CITY OF ALBUQUERQUE

**RE: Tract F-3 Winrock Town Center
2100 Louisiana Blvd.
Engineer's Stamp Date: 9/5/2022
Hydrology File: J19D055**

Based upon the information provided in your submittal received, the Grading & Drainage Plan is approved for Building Permit. The following items will be needed prior to Certification of Occupancy:

PORTLAND BUILDING GRADING & DRAINAGE PLAN

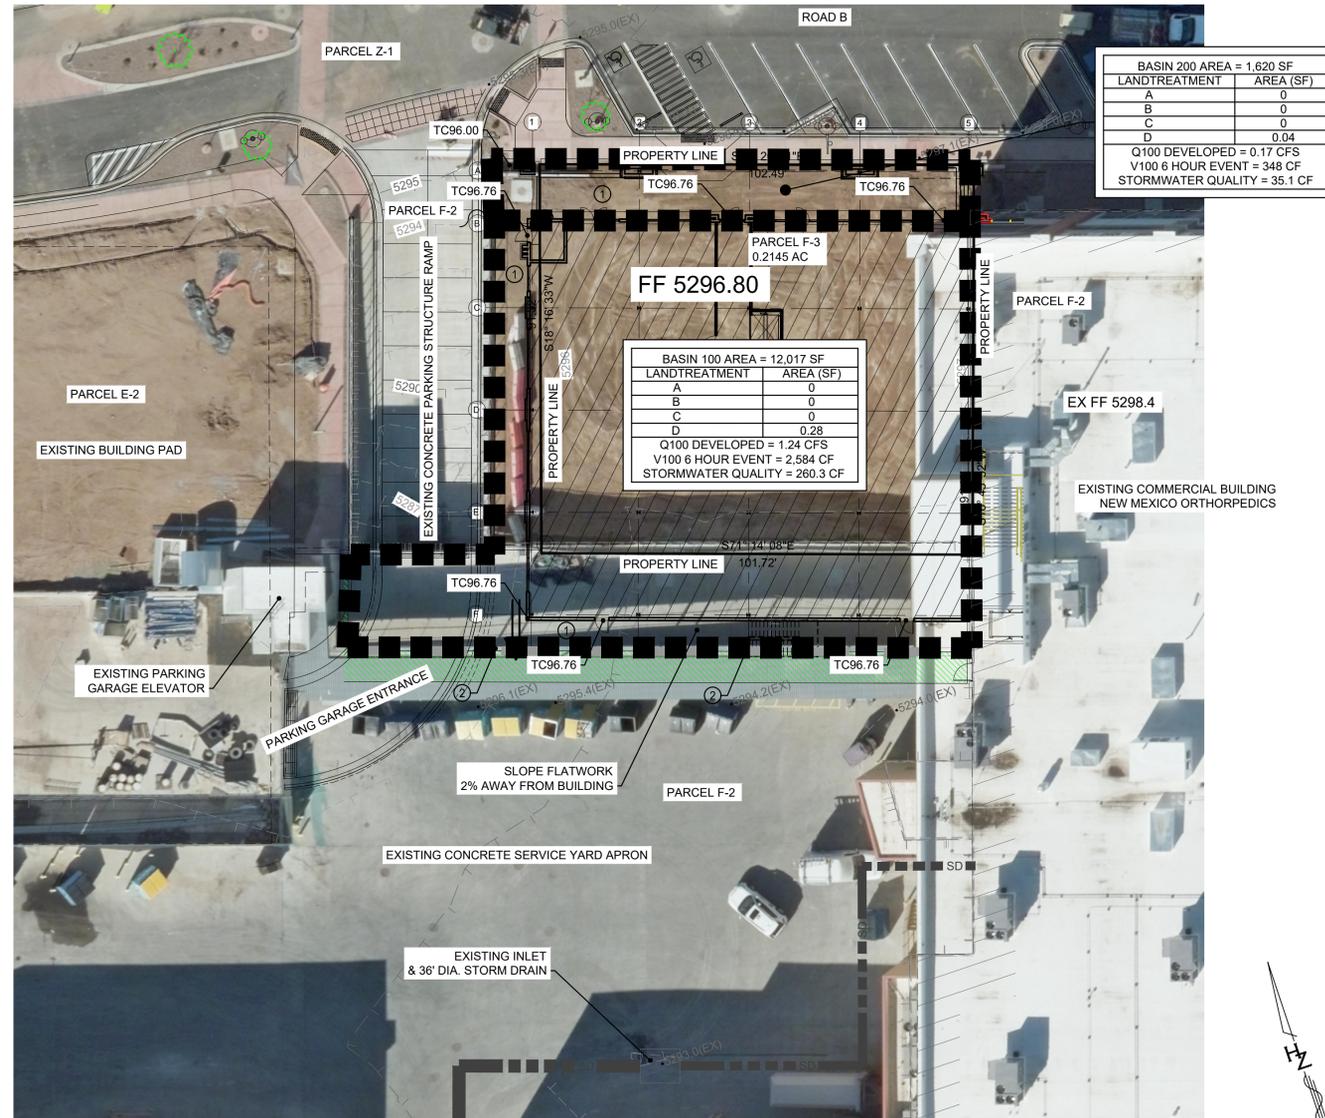
1. As-built plans.
2. Explanation and plans to how the runoff from this site will reach to lake for first flush volume. Was this site part of the lake drainage plan for First Flush volume requirement.

- If the project is part of a previously approved Master Drainage Plan it would be helpful to provide the City Project and a copy of the overall plan.
- It would also be helpful to provide an explanation to where the runoff from this site will drain to even though is shown on the Master Plan
